## **Independent Review of Groundwater Investigations**

**Lot 36 Abernethy Road, Oakford, Western Australia**

Prepared for:  
Department of Water and Environmental Regulation  
1st Floor West Wing, 181-205 Daly Street  
Booragoon WA 6154

3 January 2018

**Figure 1: Geological Cross Section**

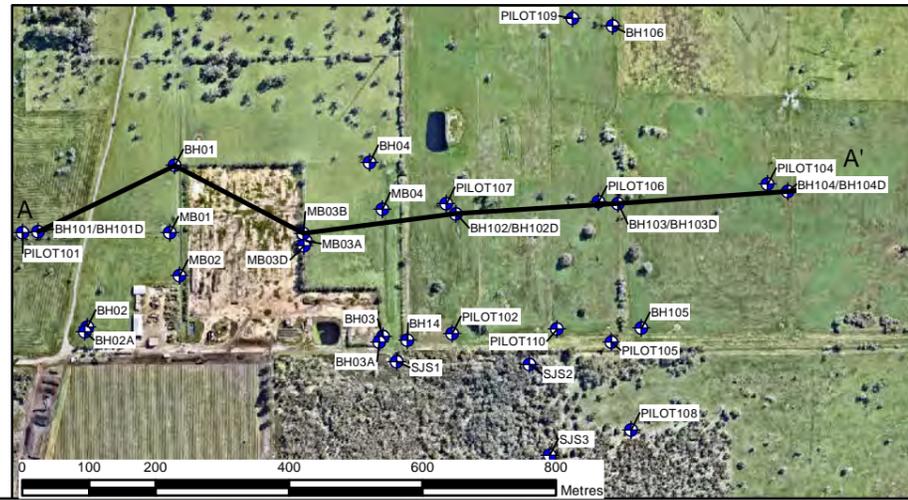
My interpretation of the geology of the site is generally consistent with that presented in the Detailed Site Investigation report and Mr Throssell's opinion and is shown in the cross section, running from west to east across the site, presented in **Figure 1**.

- None of the boreholes drilled as part of the investigations relating to the site extended to depth through the sands of the Guildford Formation. The maximum of boreholes drilled as part of investigations at the site is approximately 10 m bgl and an elevation of approximately 8 m AHD (refer to **Figure 1**).

- The Bassendean Sands do not appear to be present east of the site, beyond the location of BH102D (refer to **Figure 1**), where ground surface elevations reduce and relatively sandy sequences of the upper Guildford Formation appears to outcrop at the surface.

**Figure 5: Recommended Additional Wells**

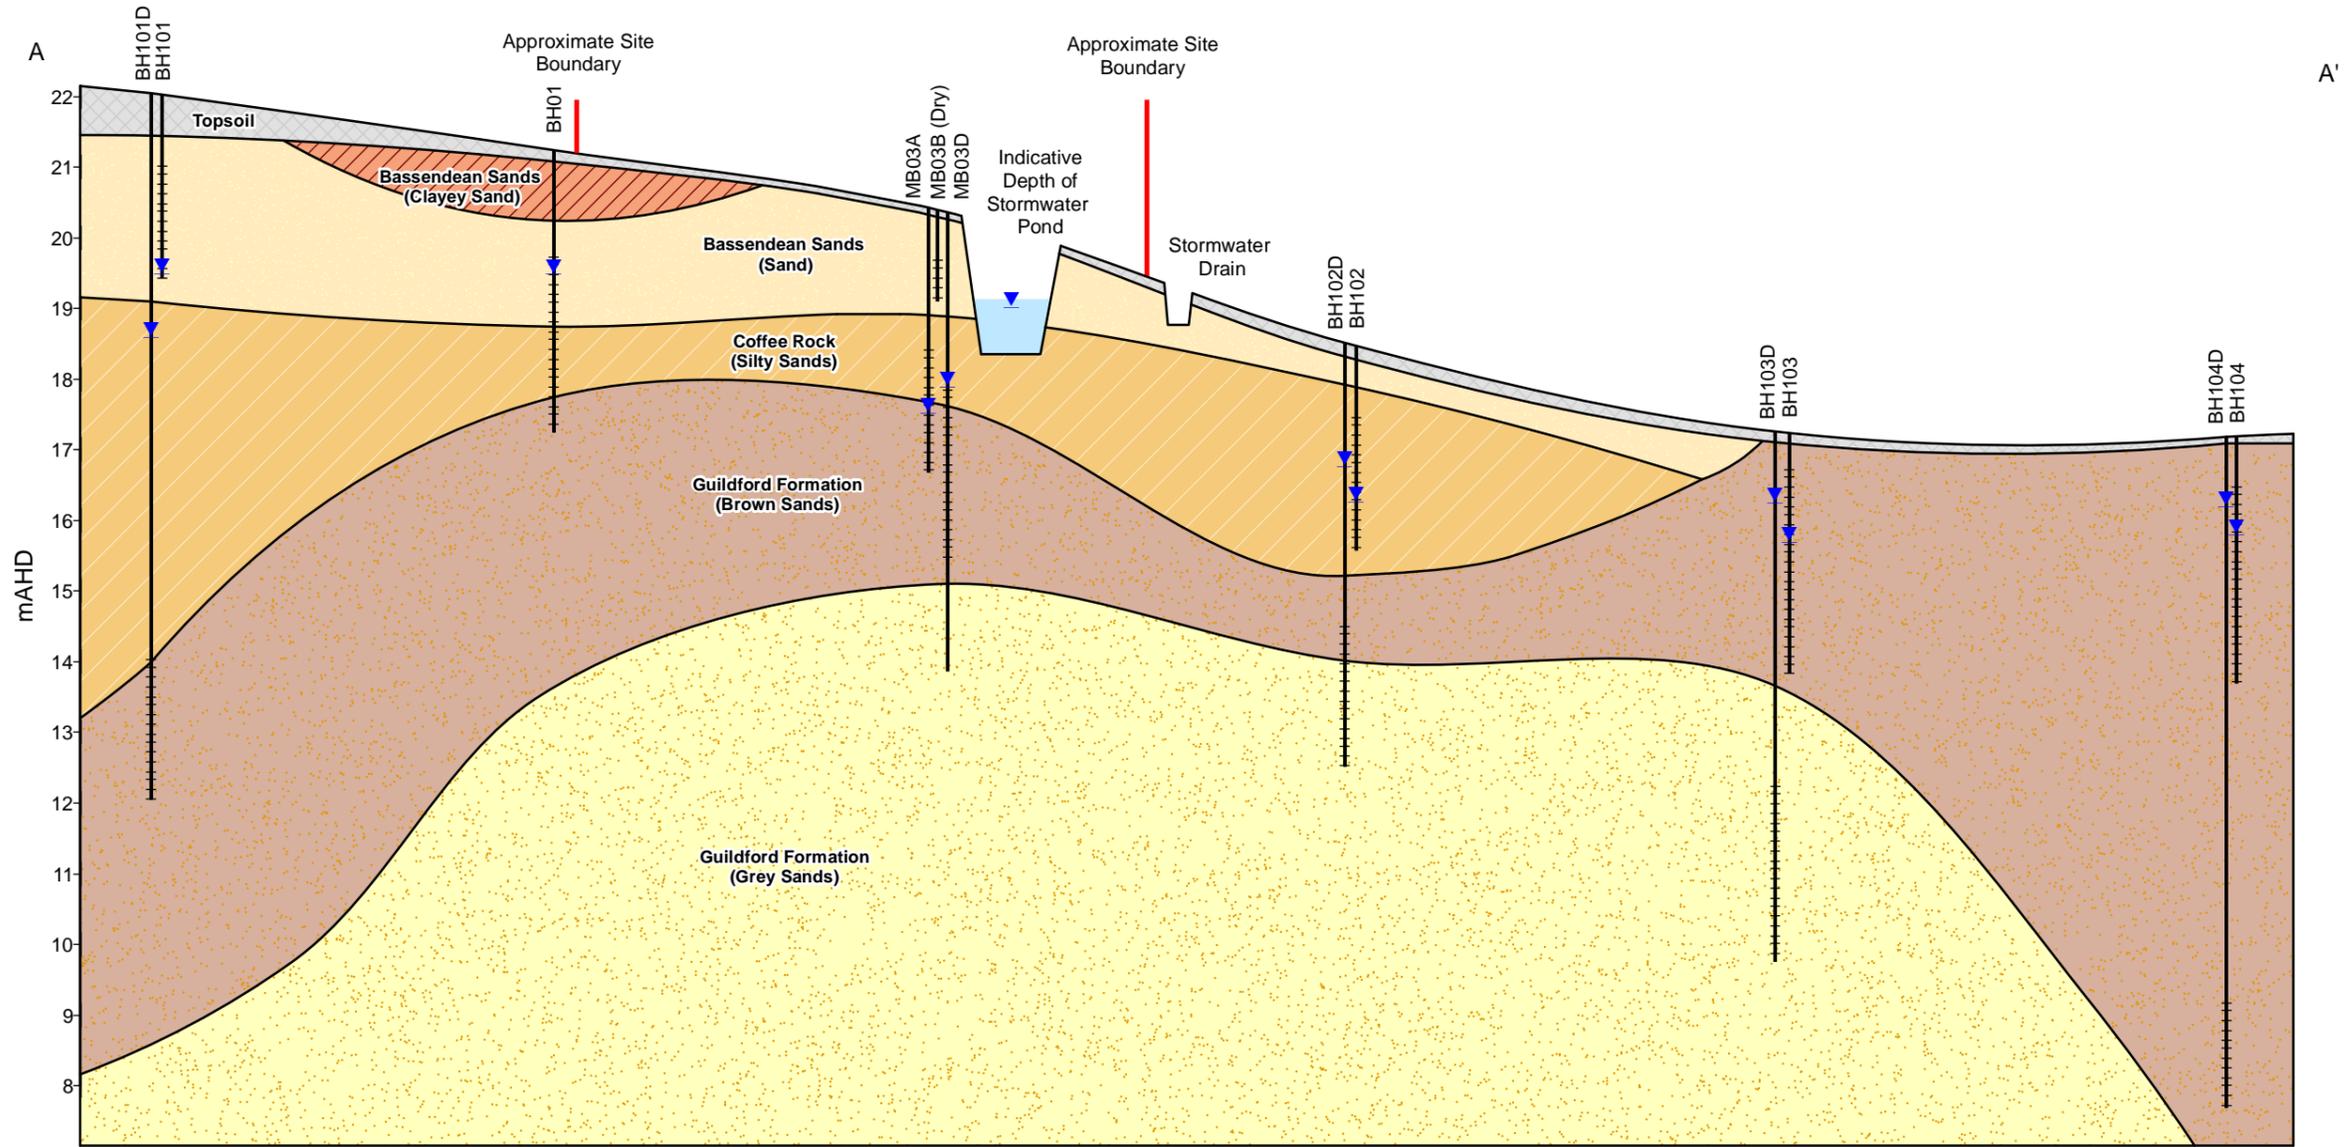
However, the vertical distribution of contaminants could be more conclusively assessed by shallow and deeper wells installed closer to specific onsite sources. Additional wells in close proximity to specific sources would also assist in confirming the vertical distribution of contaminants, refer to **Sections 5.1 and 5.5 and Figure 5**.

- At least five additional shallow wells in close proximity to specific onsite sources (refer to **Figure 5**).

- At least two additional deeper wells south and east of the Stormwater Basin, adjacent to shallow wells (refer to **Figure 5**). The deeper wells should be screened in the Guildford Sands, beneath any coffee rock that may be present in those locations (approximately 6 m to 10 m bgl), to assess vertical migration of contaminants immediately adjacent to the Stormwater Basin.

- Samples of any water remaining in onsite ponds should be collected and analysed to assess their potential as on-going sources.
- Samples of stormwater should be collected from the surface drains around the site to attempt to assess contributions from up-stream sources and the site (refer to **Figure 5**).

To more thoroughly assess risk to human health and the environment associated with groundwater impacts I would recommend additional investigation works. Recommended additional groundwater well and surface water sampling locations are shown on **Figure 5**.
